SUBJECT: ISSUANCE OF AMENDMENT (TAC NO. M86801)

NORTHEAST NUCLEAR ENERGY COMPANY
THE CONNECTICUT LIGHT AND POWER COMPANY
THE WESTERN MASSACHUSETTS ELECTRIC COMPANY
DOCKET NO. 50-336
MILLSTONE NUCLEAR POWER STATION, UNIT NO. 2
AMENDMENT TO FACILITY OPERATING LICENSE

Amendment No. 170
License No. DPR-65

SAFETY EVALUATION BY THE OFFICE OF NUCLEAR REACTOR REGULATION

FIGURE 3.4-2

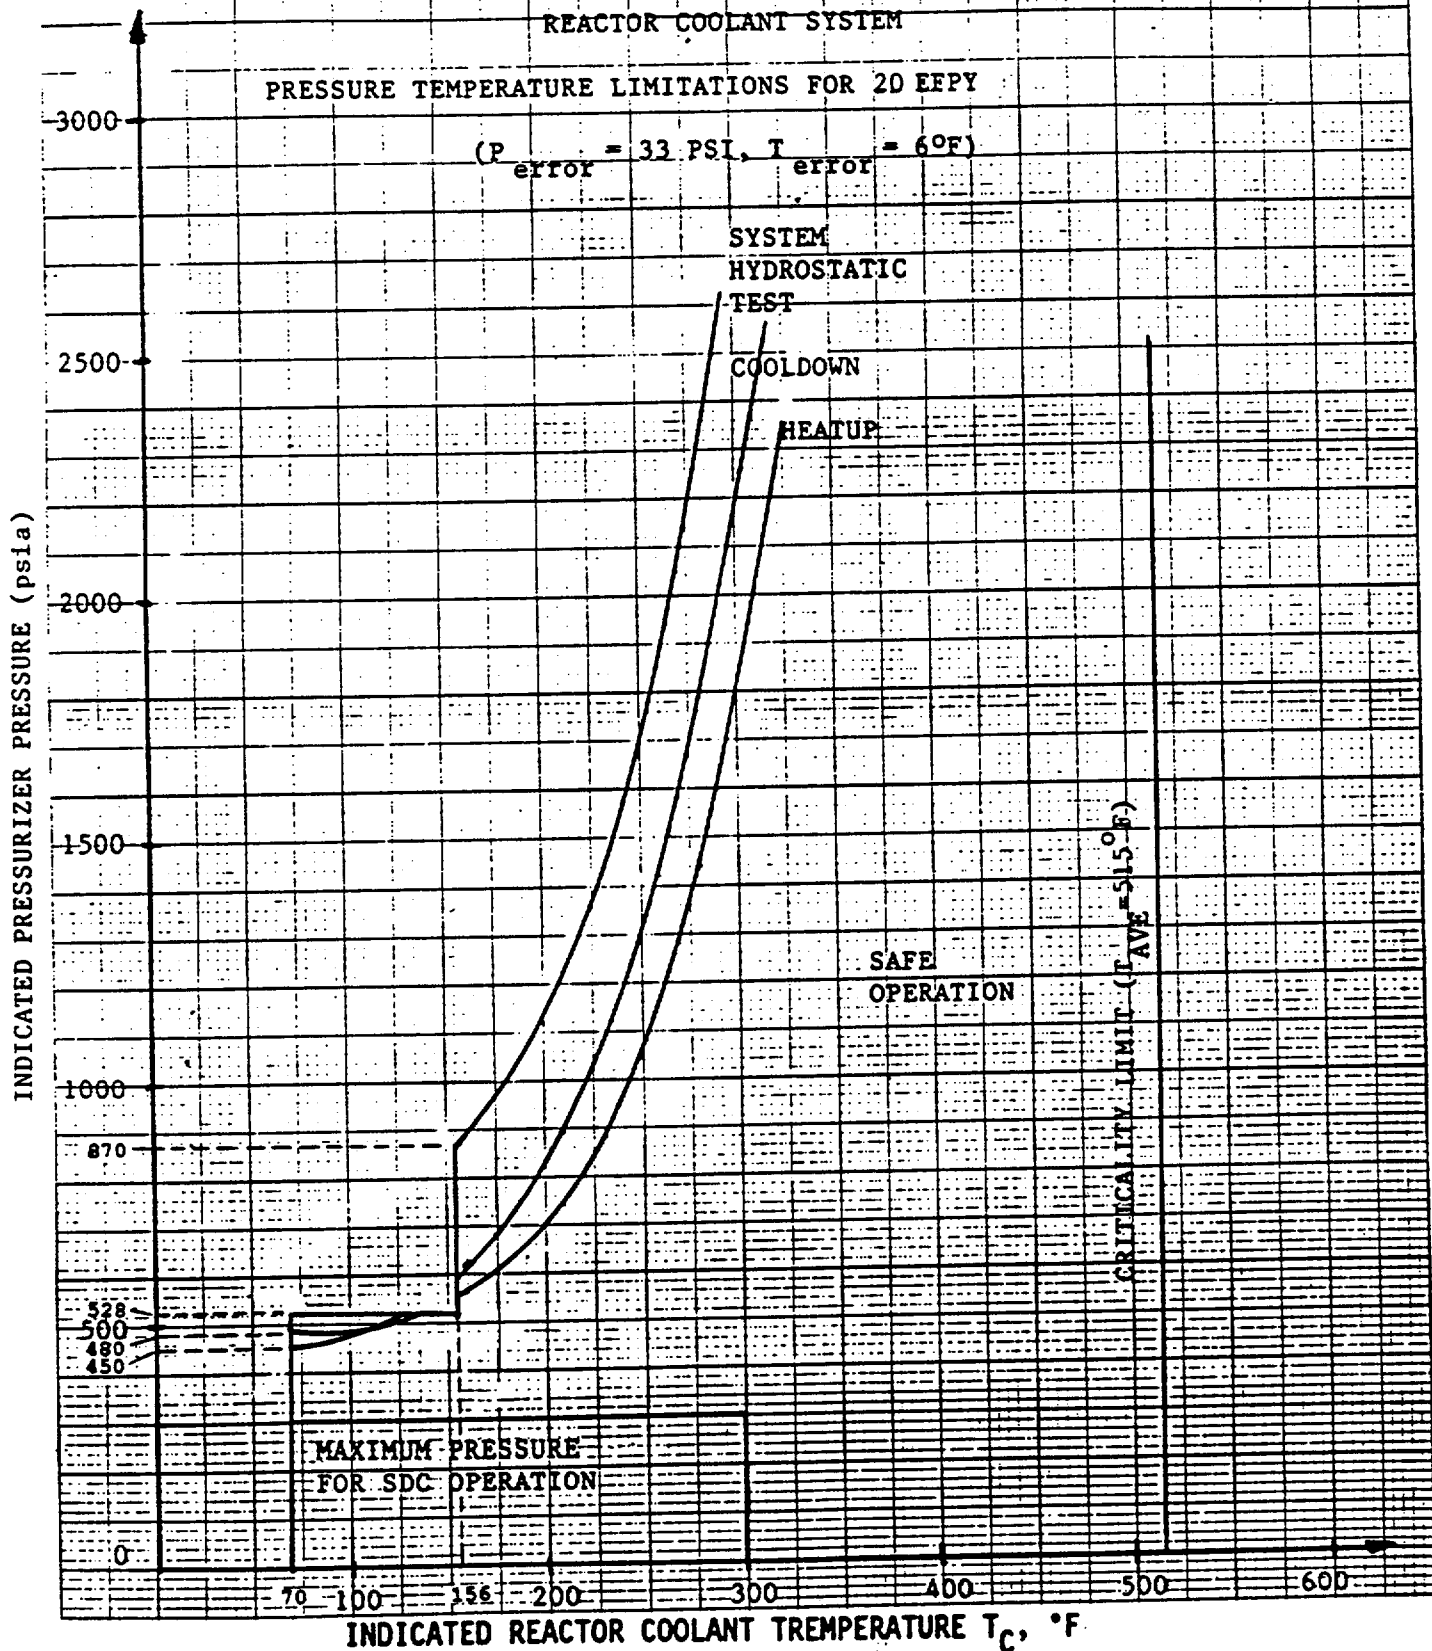
The amendment revises the pressure/temperature (P/T) limits for the reactor vessel. Specifically, Figure 3.4-2, "Millstone Unit 2 Reactor Coolant System Pressure-Temperature Limitations for 12 Full Power Years," on page 3/4 4-19, is revised to reflect the change in the curves and the title change to "Millstone Unit 2 Reactor Coolant System Pressure-Temperature Limitations for 20 EFPY."

The amendment revises the pressure/temperature (P/T) limits for the reactor vessel. Specifically, Figure 3.4-2, "Millstone Unit 2 Reactor Coolant System Pressure-Temperature Limitations for 12 Full Power Years," on page 3/4 4-19, is revised to reflect the change in the curves and the title change to "Millstone Unit 2 Reactor Coolant System Pressure-Temperature Limitations for 20 EFPY."

The staff calculated the ART for each beltline material in the Millstone 2 reactor vessel in accordance with RG 1.99, Rev. 2. The staff determined that the material with the highest (limiting) ART at 20 EFPY was the intermediate shell plate C-505-2 (heat number C5843-2) having 0.13% copper (Cu), 0.64% nickel (Ni), and an initial RT_{ndt} of 25°F.

The staff calculated the ART to be 143°F at the 1/4T location (T = reactor vessel beltline thickness) and 113°F for the 3/4T location. The staff used a neutron fluence of $9.32E18$ n/cm² at 1/4T and $2.79E18$ n/cm² at 3/4T. The staff used the method in Regulatory Position C.2, Surveillance Data Available, in RG 1.99, because the surveillance data are credible.

For the same limiting material, the licensee calculated an ART of 145°F and 118°F at the 1/4T and 3/4 locations, respectively, using Regulatory Position C.1, Surveillance Data Not Available, in RG 1.99.

RG 1.99 allows use of either methods to calculate the ARTs. RG 1.99 states that if Position C.2 gives a higher value of ARTs than that given by using Position C.1, the ARTs from Position C.2 should be used. If Position C.2 gives lower ARTs, either may be used. The licensee's ARTs are more conservative than the staff's ARTs and, therefore, acceptable to use.

Substituting the ARTs of 145°F and 118°F into equations in SRP 5.3.2, the staff verified that the proposed P/T limits for heatup, cooldown, and hydrotest meet the requirements in Paragraphs IV.A.2 and IV.A.3 of Appendix G of 10 CFR Part 50.

The staff has performed an independent analysis of the P/T limits to verify the licensee's proposed limits. The staff concludes that the proposed P/T limits for heatup, cooldown, hydrostatic tests, and criticality are valid through 20 EFY because the limits conform to the requirements of Appendices G and H of 10 CFR Part 50 and Generic Letter 88-11. Hence, the proposed P/T limits may be incorporated in the Millstone 2 Technical Specifications.
